Memo

TO: Public Works Committee
 FROM: Ed Andrews, Public Works Director
 DATE: June 1, 2018
 SUBJECT: Discussion of Combined Driveway Standard
 For existing rehab requests

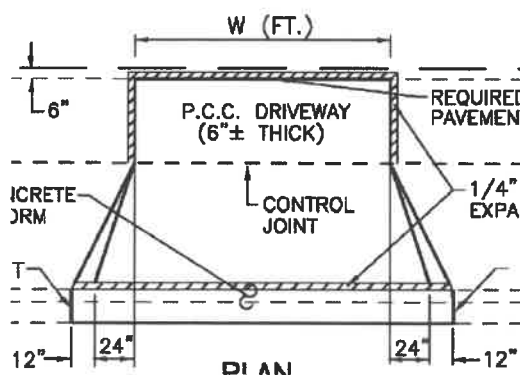
A recent request from Roger Harter of 511 Monroe Street wishes to construct ½ of a combined apron. Current conditions are shown below.

Staff has taken the opportunity to lay out City Standard 015 at the area in question and finds that a standard installation is feasible, but the Owner feels that a combined entrance is more fitting.

DRIVEWAY ENTRANCE DETAIL FOR CURB OPENINGS WITH SIDEWALK/PARKWAY

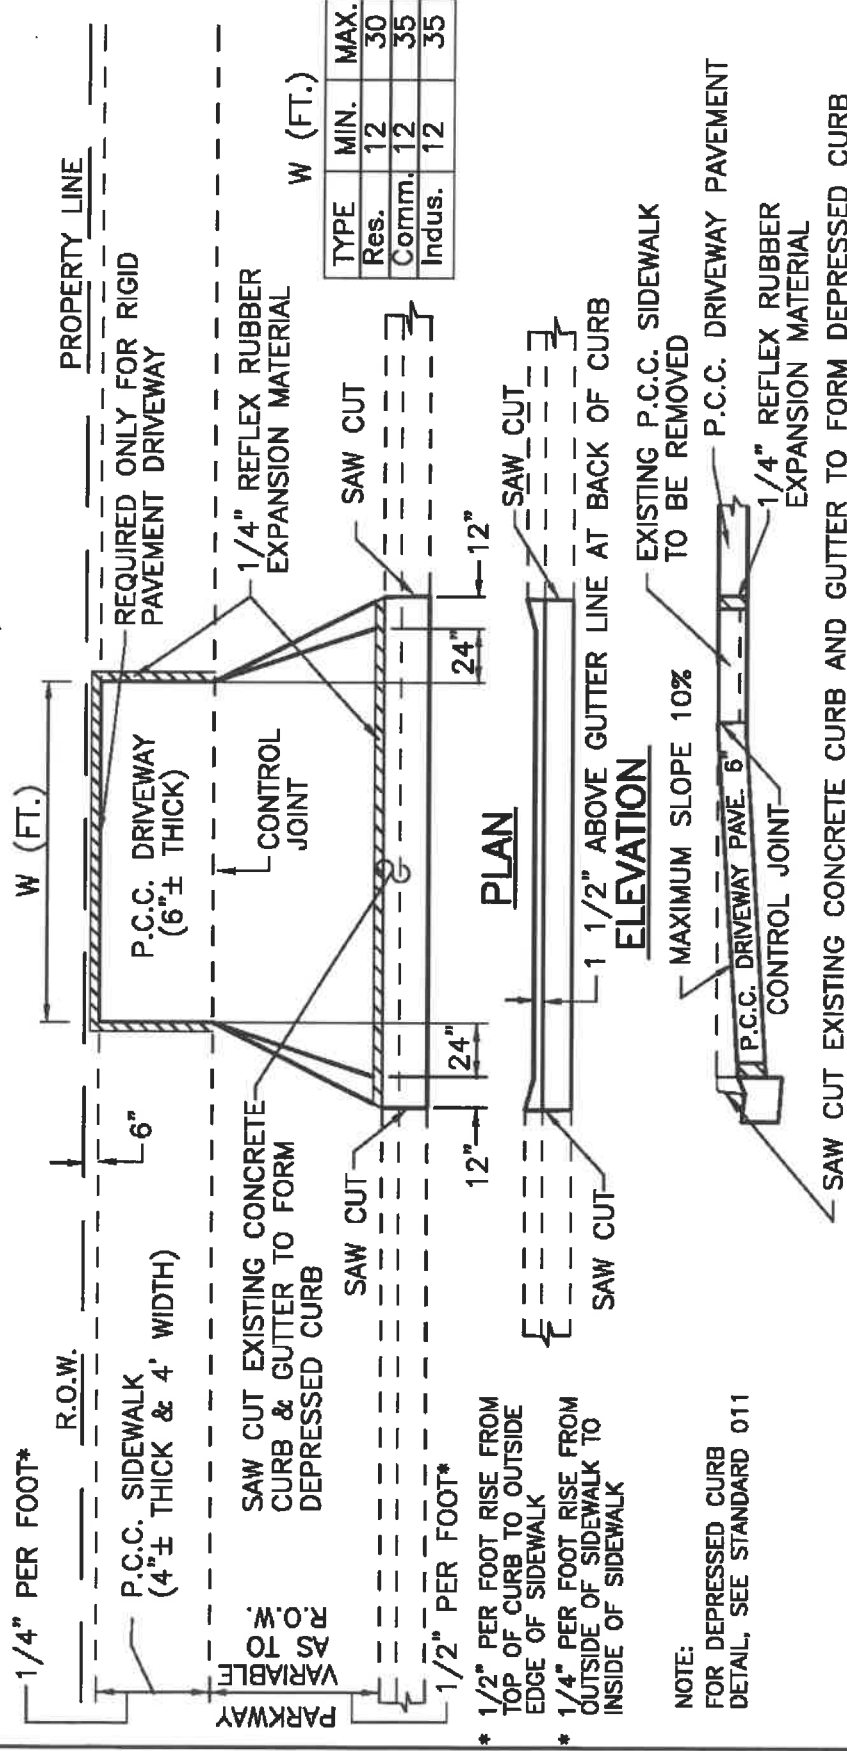
Current standards do not provide for a combined driveway, an excerpt of City Standard 015 is shown below and a complete copy attached herewith.

Since there currently is no combined standard, the request to establish one and how to limit its use is being presented for discussion with Committee.
